- MARVIN R. KORTUM, NMPE 6519**
- REVISIONS TO THE ORIGINAL PLAN, REVIEWED AND APPROVED BY THE HYDROLOGY SECTION ON OCTOBER 6, 2005, HAVE BEEN CONSTRUCTED, AS DESCRIBED BELOW:**

DRAINAGE AND GRADING PLAN FOR ASPEN/3RD STREET BUILDINGS 300 ASPEN AVENUE N.W.

PROJECT TITLE: WAREHOUSE ON ASPEN

SHEET TITLE: DRAINAGE AND GRADING PLAN

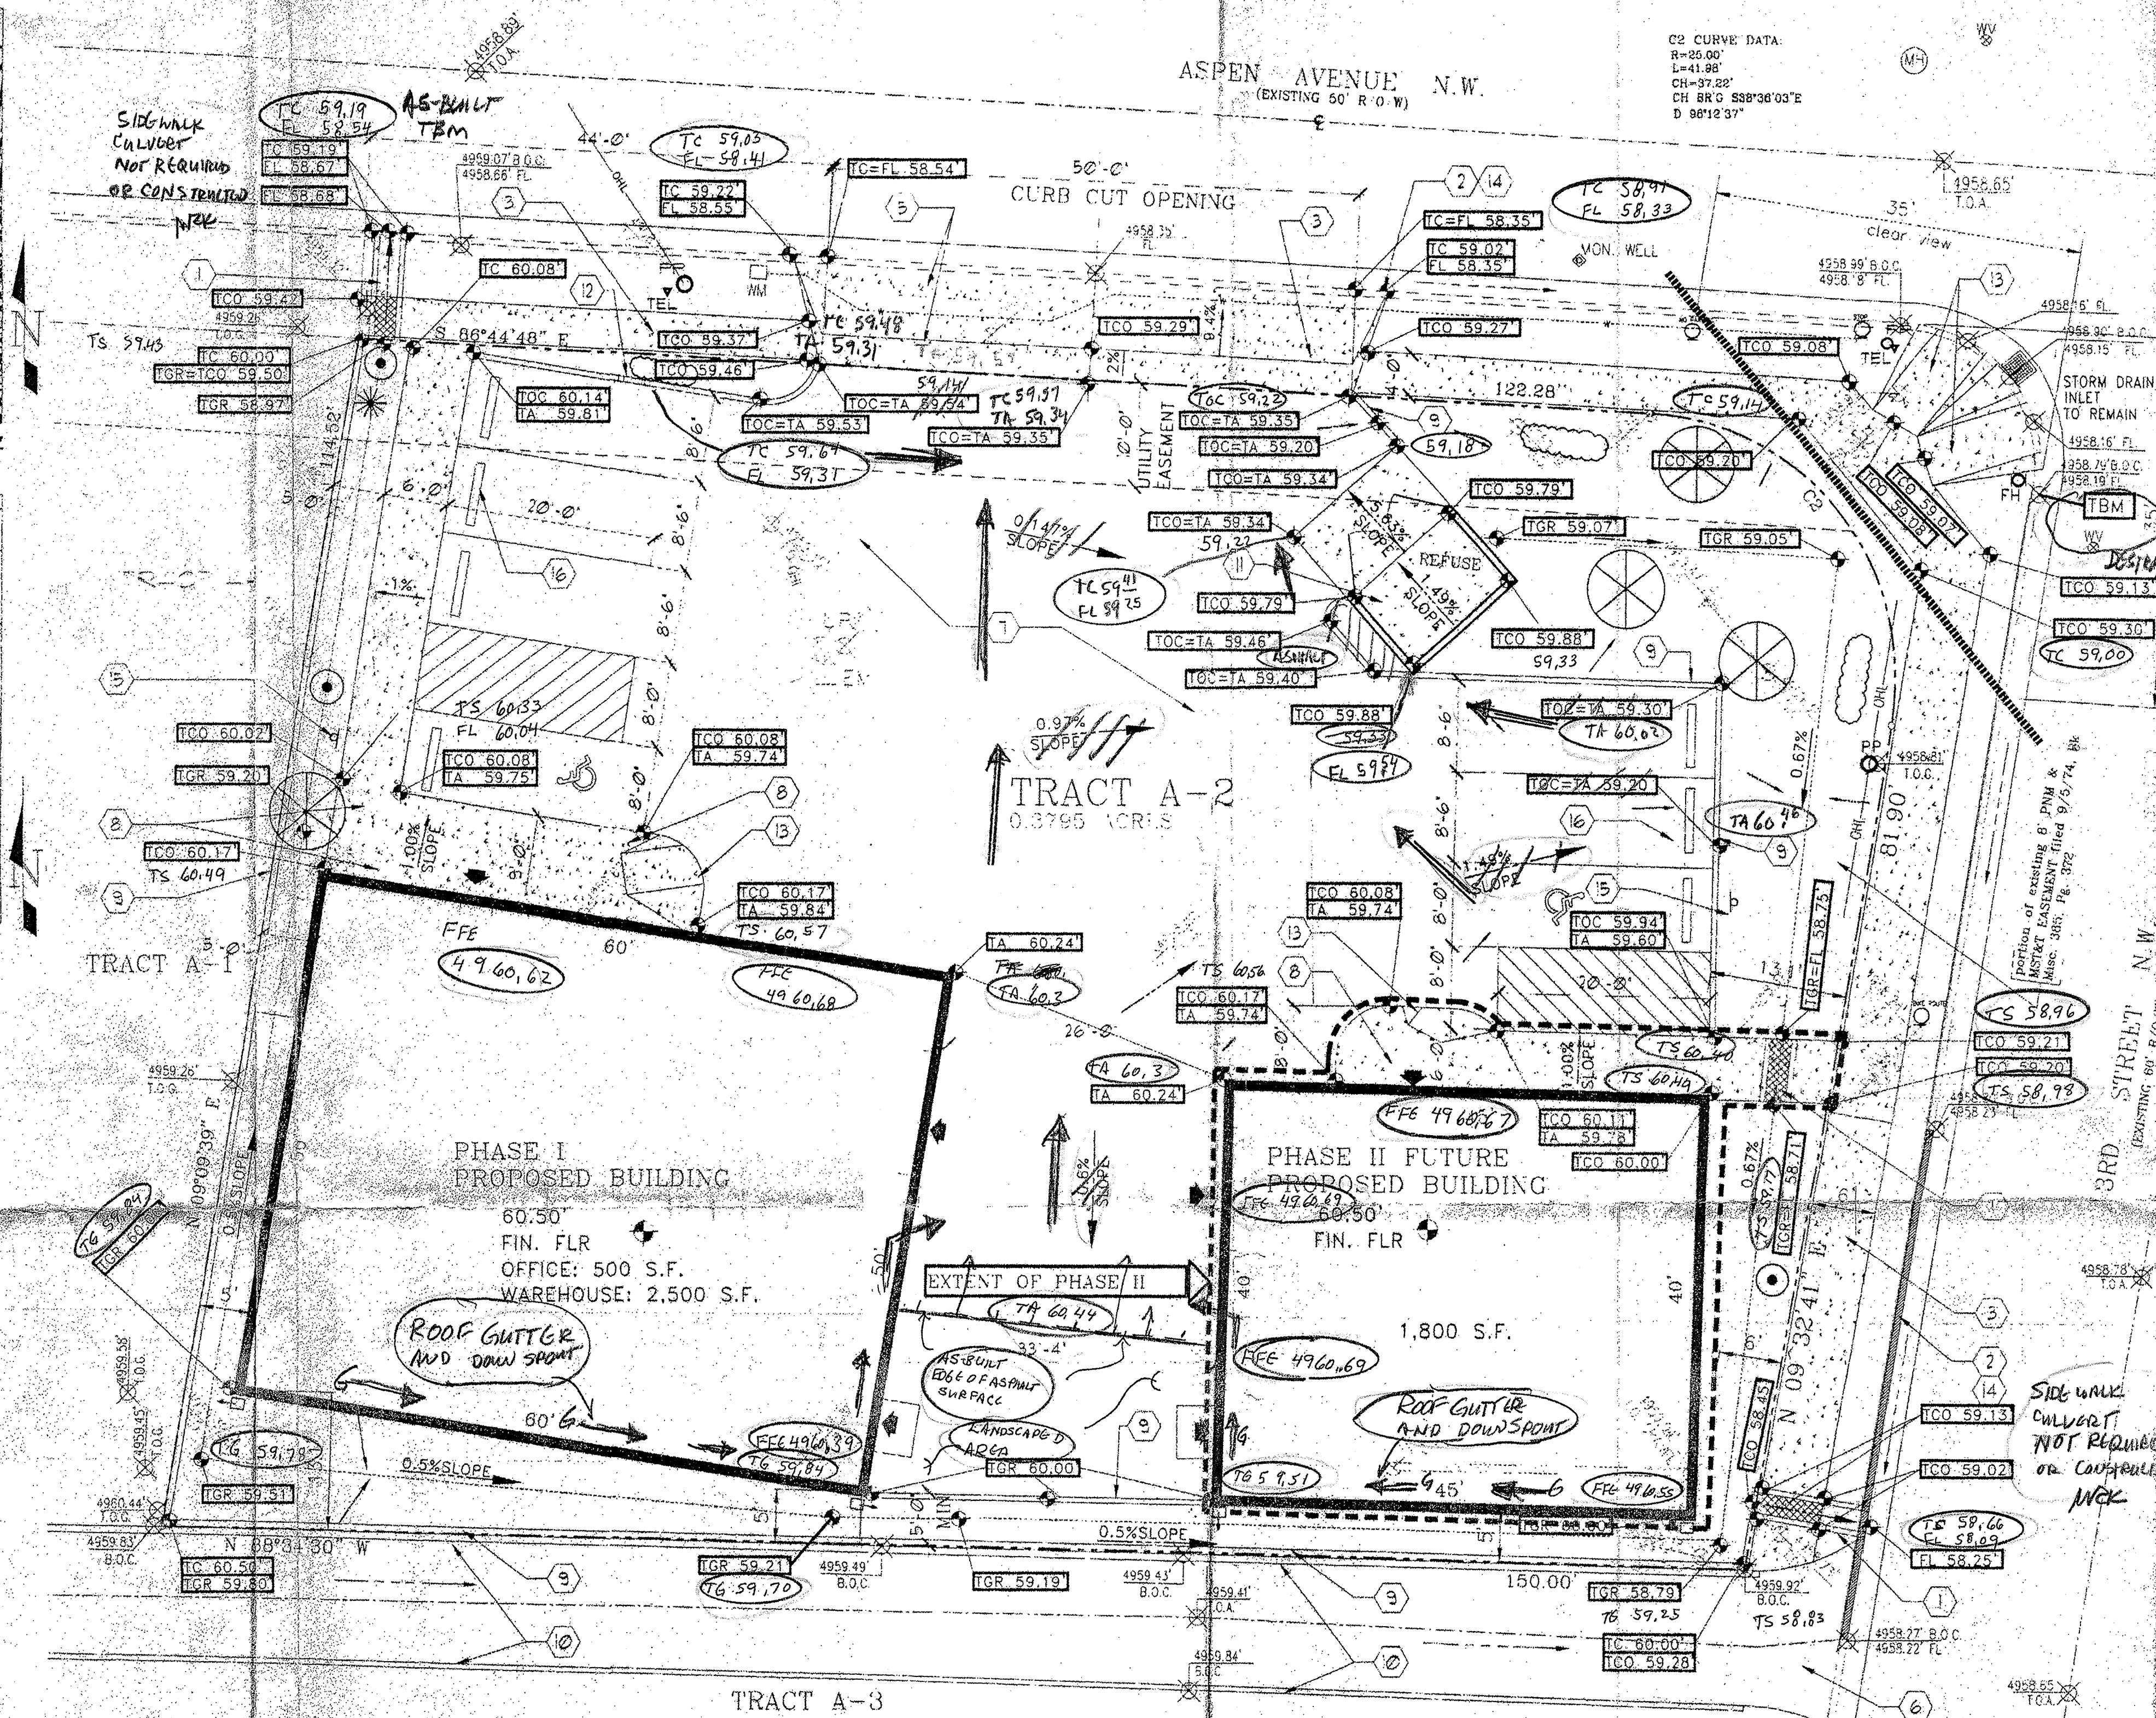
- HANDICAPP PARKING SIGN.
 - CONCRETE TIRE STOP.
- CHANGED TO TREATED TIMBER**
- APPROVAL**
- | APPROVAL | NAME | DATE |

- THE RUNOFF FROM IMPERVIOUS SURFACES THAT FLOWS TO THE SOUTH PART OF THE PROPERTY FROM THE SOUTH HALF OF THE PITCHED ROOF ON THE TWO BUILDINGS IS NOW DIRECTED TO A GUTTER AND DOWN SPOUT INSTALLED ON THE BUILDINGS, WITH THE DOWN SPOUT DIRECTING THE ROOF RUNOFF TO THE ASPHALT DRIVEWAY BETWEEN THE TWO BUILDINGS.

- A TREATED TIMBER CURB IS SUBSTITUTED FOR THE CONCRETE HEADER WALL THAT WAS APPROVED ALONG THE SOUTH AND WEST PROPERTY LINES.
 - THE ASPHALT SURFACED DRIVEWAY HAS BEEN RE-SURFACED TO DIRECT RUNOFF TSO THE DRIVEWAY AND INTO THE GUTTER ALONG ASPEN AVENUE NW.

- THE SIDEWALK CULVERTS AT THE SOUTHWEST CORNER, ON ASPEN AVENUE NW, AND AT THE NORTHEAST CORNER, ON 3RD STREET HAVE BEEN DELETED AS A REQUIREMENT BECAUSE ALL RUNOFF FROM IMPERVIOUS SURFACES IS DIRECTED TO THE DRIVEWAY ON ASPEN AVENUE NW.
